229A - Piper

SUBJECT:
Removal of Restriction to Airspeed Limits

MODELS AFFECTED:
PA-30 Twin Comanche, Serial Nos. 30-853, 30-902 to 30-1159 incl.

SKETCH A

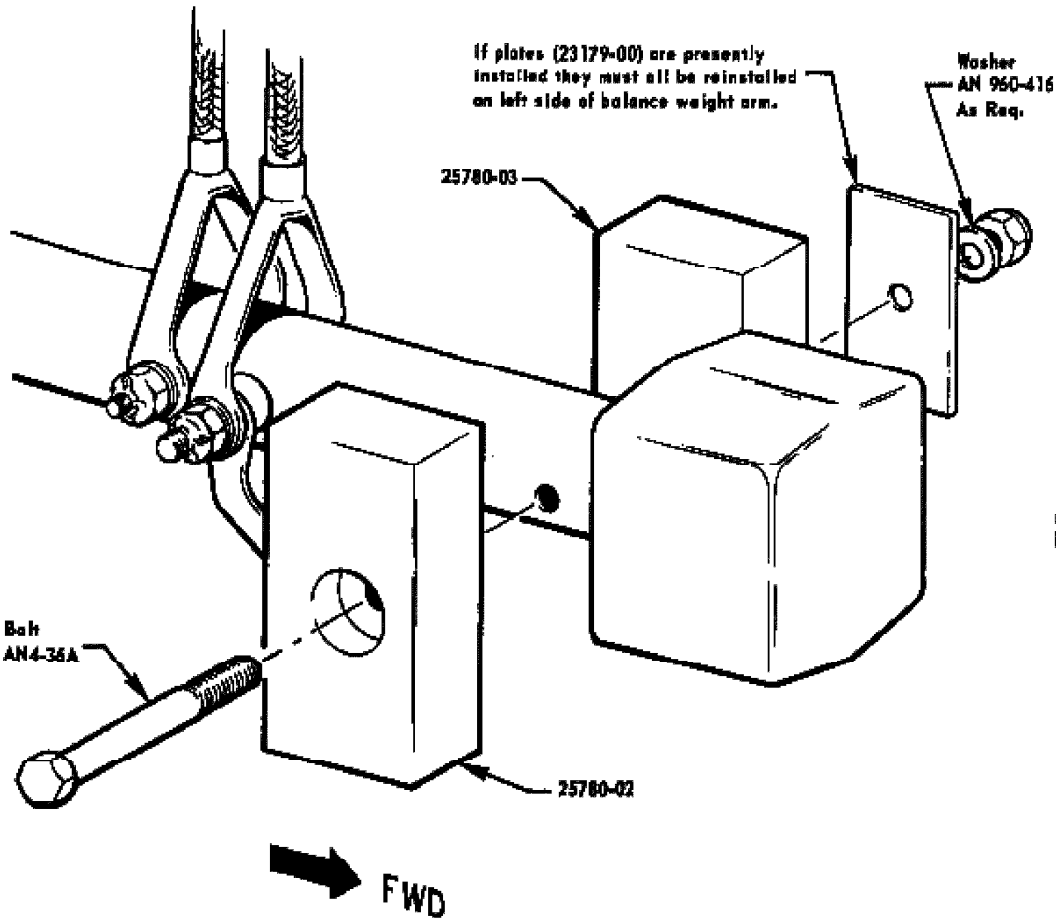
It has been determined that the installation of balance weights, part numbers 25780-02 and 25780-03 in addition to the standard balance weight, part number 23594-00, will eliminate this vibration, however, the original never-exceed airspeed limit, 245 MPH, must be reduced to 240 MPH.

A placard for the airspeed indicator, a revised Flight Manual, Stabilator Balance Weights and an AN4-36A bolt are contained in Kit 757 044. Information concerning the installation of this kit is contained on sketch "A" below this bulletin.

e. After balancing is accomplished, the check weight should be removed and the front attachment bolt connecting the stabilator balance weight to the stabilator balance arm shall be removed and weights, part nos. 25780-02, 25780-03 and bolt AN4-36A and stabilator balance weight plates 23179-00 shall be installed at this attachment point. Stabilator balance weight, part no. 25780-02 shall be installed on the right side of the stabilator balance arm and stabilator balance weight, part no. 25780-03 and stabilator balance weight plates 23179-00 shall be installed on the left side of the stabilator balance arm.

Balance weight, part no. 25780-02 shall be installed such that the counterbore and bolt head face outboard on the right side of the balance arm.

SKETCH B

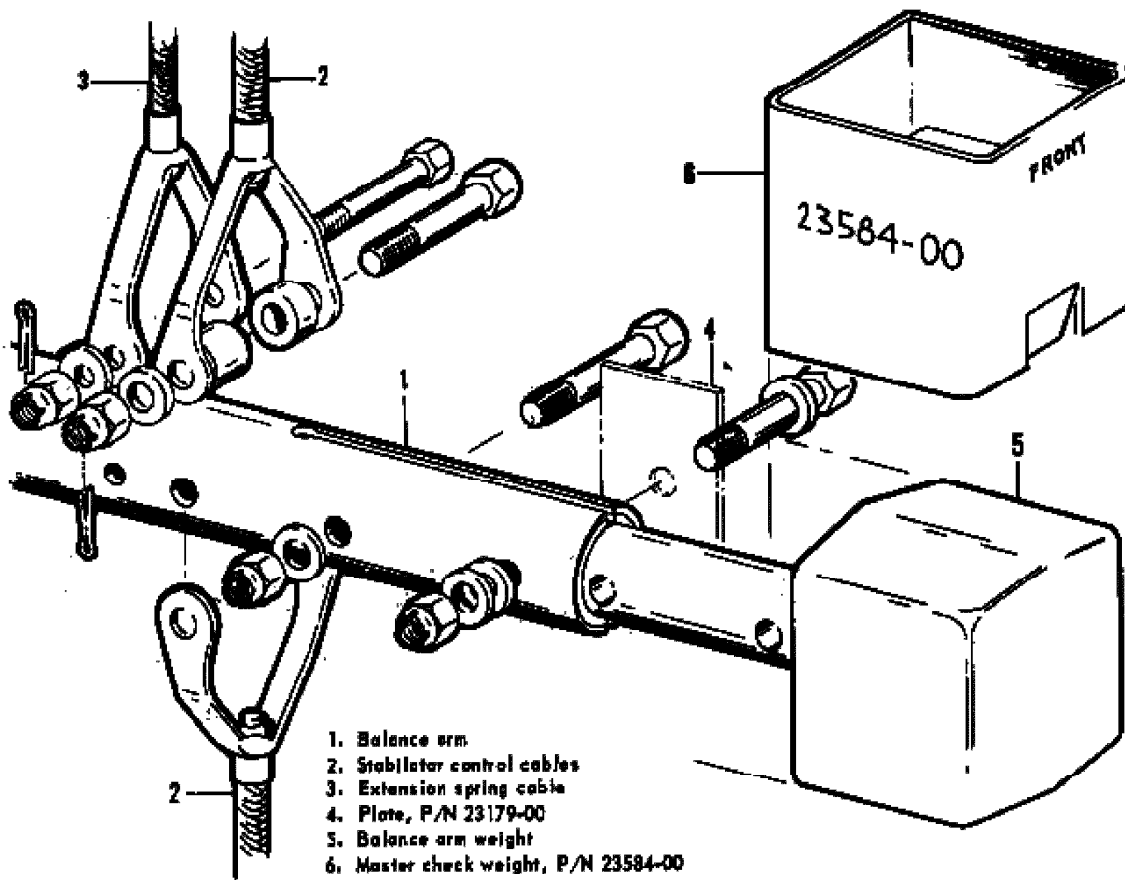
If alterations or repairs to the stabilator installation were made, the stabilator must be rebalanced in accordance with the balancing instructions and sketch "B" below this bulletin prior to the installation of Kit 757 044.

NOTE
If balancing of the stabilator is required in the future, balance weights 25780-02 and 25780-03 and the AN4-36A bolt contained in Kit 757 044 must be removed. Balancing shall then be accomplished in accordance with the attached balancing instructions and sketch "B". Kit 757 044 must be reinstalled after balancing is completed. The balancing information contained herein shall become a part of the PA-30 Twin Comanche Service Manual on a revision to be issued in the near future.

c. Master check weight 23584-00 (weight 1.58 pounds) should be placed on top of balance weight 23594-00 with side marked "FRONT" facing forward. If this is not enough weight to obtain static balance with the balance arm level, plates 23179-00 must be added to the forward balance weight attachment bolt until 100% static balance is obtained or until up to two plates more than that required for balance have been added. It should never be necessary to use more than eight plates. If a total of more than eight plates are necessary to obtain balance, the manufacturer should be consulted.

d. If it should become necessary in the field to balance a stabilator without a master check weight, a temporary balancing can be accomplished by following the procedure given in "b" above except that instead of using a master check weight a sensitive and accurate spring scale can be used to get a balance with 49 ± 0.3 inches pounds of torque. Thus plates should be added (up to eight) until a lifting force of between 2.71 and 2.88 pounds will balance the stabilator with the spring scale being hooked to the bolt which fastens the two stabilator-connecting tabs together (arm of 17 inches). As soon as a master check weight is available the balance should be checked for accuracy.
